Paper No. CB(2)995/99-00(02)

**LEGISLATIVE COUNCIL SUBCOMMITTEE TO FOLLOW UP  
ON THE OUTSTANDING CAPITAL WORKS PROJECTS OF  
THE TWO PROVISIONAL MUNICIPAL COUNCILS FOR  
INCLUSION INTO THE GOVERNMENT'S  
PUBLIC WORKS PROGRAMME**

**370RO – Hammer Hill Road District Park**

**303CR - Hammer Hill Road District Park  
(Layout Plan and Cost Estimate)**

Appendix II  
(Option A)

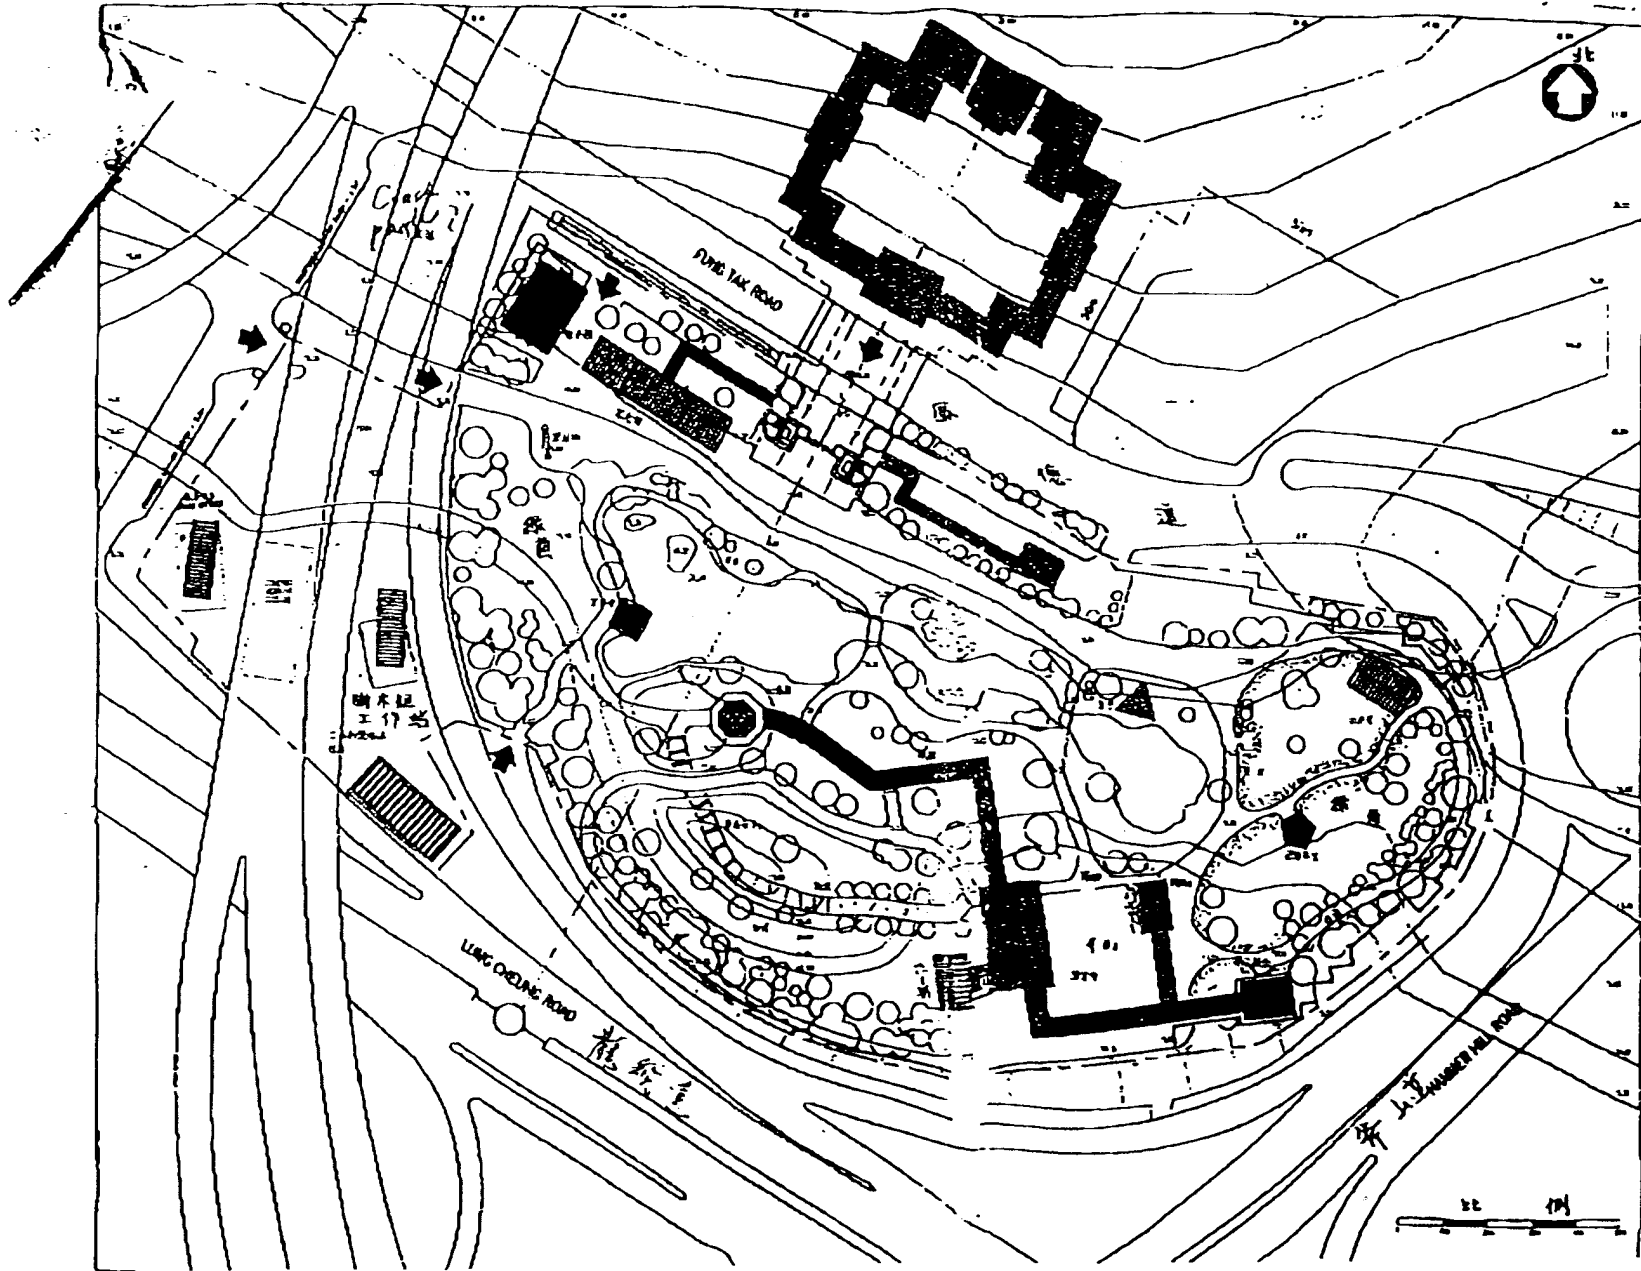
#### Option A (Appendix II)

- a) This is a design based on the approved conceptual layout featuring -
  - (i) a traditional Chinese garden in the style of the Tang Dynasty;
  - (ii) adequate access points will be strategically positioned for visitors from the MTR exit at Hollywood Plaza, the proposed coach park and residential areas at Fung Tak Road and Hammer Hill Road. The main entrance will be located at Fung Tak Road with access to the landscaped deck linking to the Local Open Space development on the opposite side of the road;

This design covers all the features in the approved schedule of accommodation and conceptual layout with quality art works and decorations signifying the culture of Tang Dynasty. There is a bountiful supply of shelters in the form of pavilions and covered walkways. From the design point of view, the pavilions and covered walkways are essential in creating different focal points of interest. They also act as natural space dividers for different planting design.

There are many structures and the cost is relatively high. It is the most expensive option (\$205.28 million inclusive of 16% on-cost in MOD price).

**Appendix IV**  
**(Option C)**

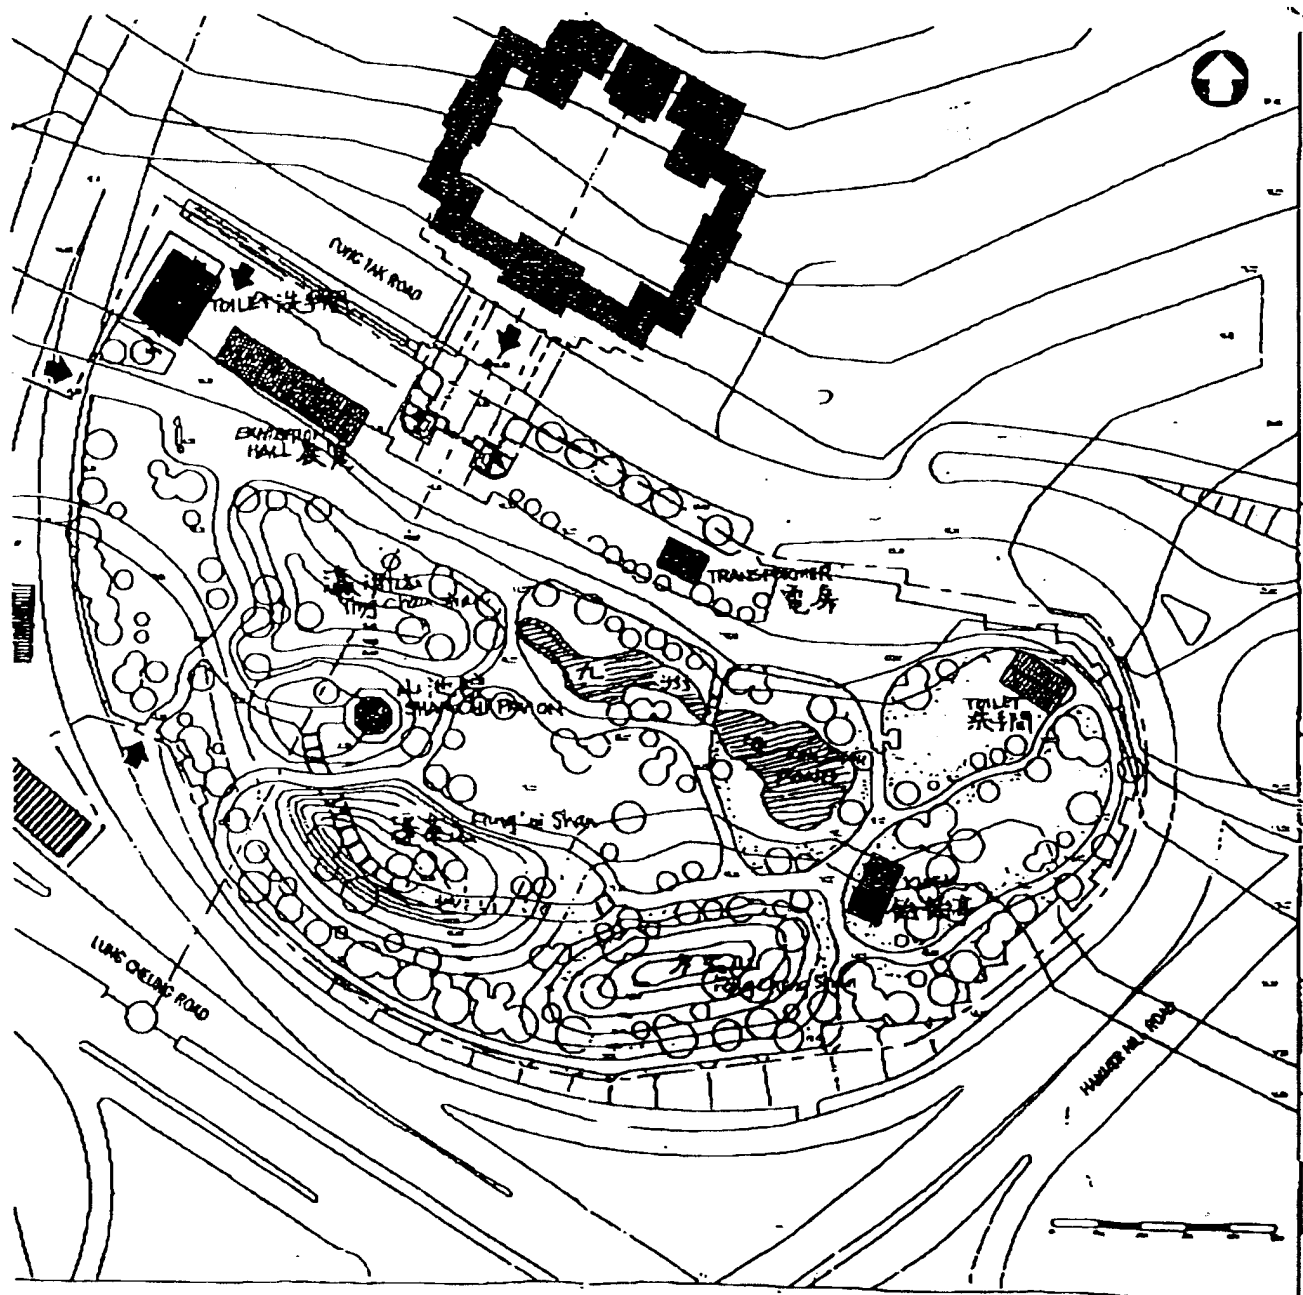
- g) This is the design with the lowest estimated cost i.e. \$133.96m (MOD price). There is a further reduction in the number of structures as compared to Option A. They include -
- (i) all the covered walkways;
  - (ii) the Senior Citizens Hall;
  - (iii) four pavilions (Calligrapher's Pavilion, Poet's Pavilion, Zhen Han Pavilion and Painter's Pavilion);
  - (iv) the Tang Gong platform;
  - (v) islands;

- (vi) a pond and a bridge; and
- (vii) a small toilet in the south.
- h) The reduction in structures will be replaced by the addition of artificial hills and planting areas. This simple design deviates significantly from the approved conceptual layout. Apart from the kiosk, there will be only one pavilion providing shelter to the public.
- i) The pros and cons of this design are -

This is the least costly design with the most soft landscaping area and open space. The estimated cost is \$133.96m (MOD price). It is lower than Option A by \$71.32m and Option B by \$43.61m (MOD price). This design places heavy emphasis on the imitation of nature with rocks, water, planting, etc. It creates a very serene surrounding.

This is a total different approach. According to the project architect, the three artificial hills and the pond may give an impression to some visitors that the park is a Buddhist garden. Besides, there is only one pavilion in the park which is considered insufficient in providing shelters to the public. Toilet facilities are also less than those in Option A.

9. Of the three options set out in para. 5 above, CLN favoured Option C.

-  Site Boundary
-  Proposed Car Park
-  Proposed Direct Access

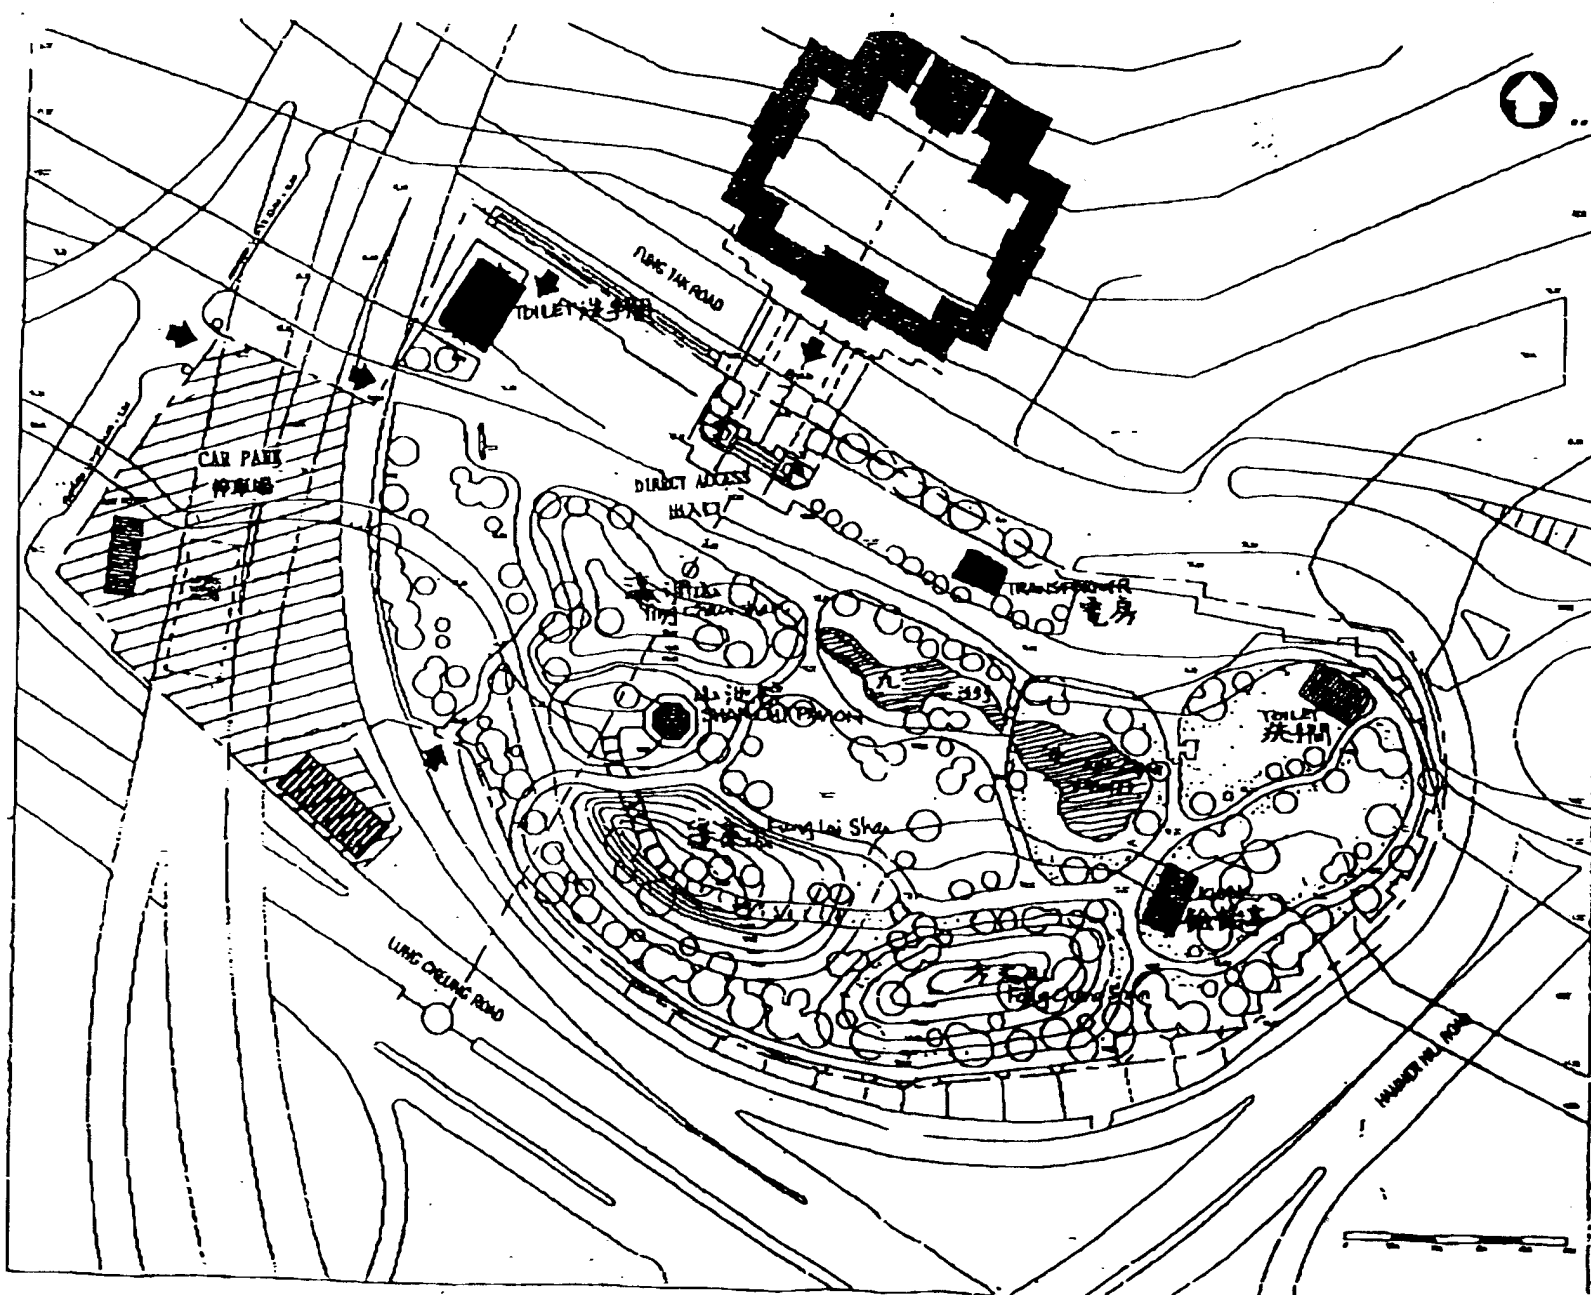
- to reduce the hard-structure element by deleting the covered walkways, exhibition hall, senior citizens' hall, tree depot and some pavillions;
- to provide a visitors' carpark at the western end of the park; and
- to provide a direct access from the park to the Chi Lin Nunnery Complex.

A preliminary conceptual plan is at Annex 2.
